Inspection of Automatic Sprinkler System

C2 Yanfeng Automotive Interiors East
London Industrial Development Zone

UNC.6901

09.05.2024 08:00 SAST

Photo 9

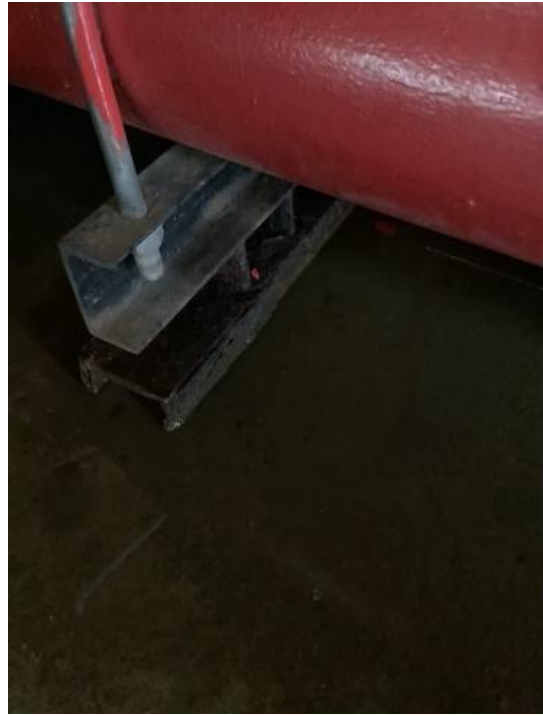
7.9 Are the Installation Control Valves Housed within an Approved Valve Cabinet	Yes
7.10 Flow Switch Installed Correctly	Yes
7.11 Manifold Correctly Supported	No

Not bolted

The valve manifold must be adequately supported.

Photo 26

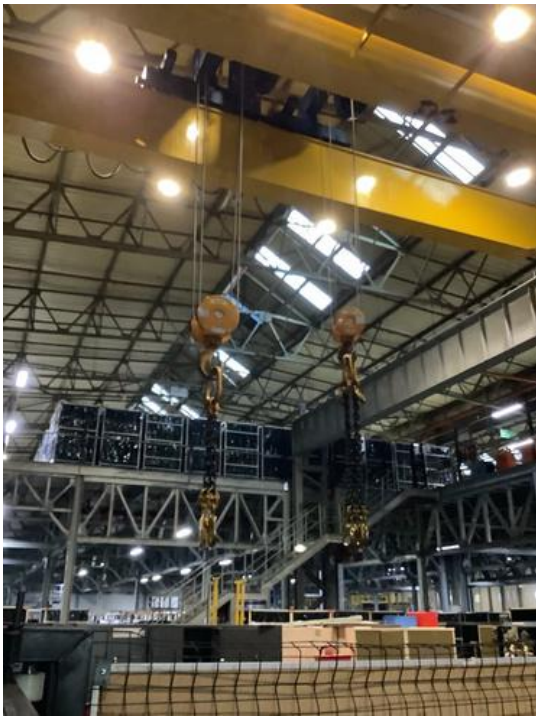
Maximum roof angle exceeded.
The maximum roof angle of 9,5 degrees for effective ESFR protection appears to have been exceeded, this must be investigated and addressed by your installer.
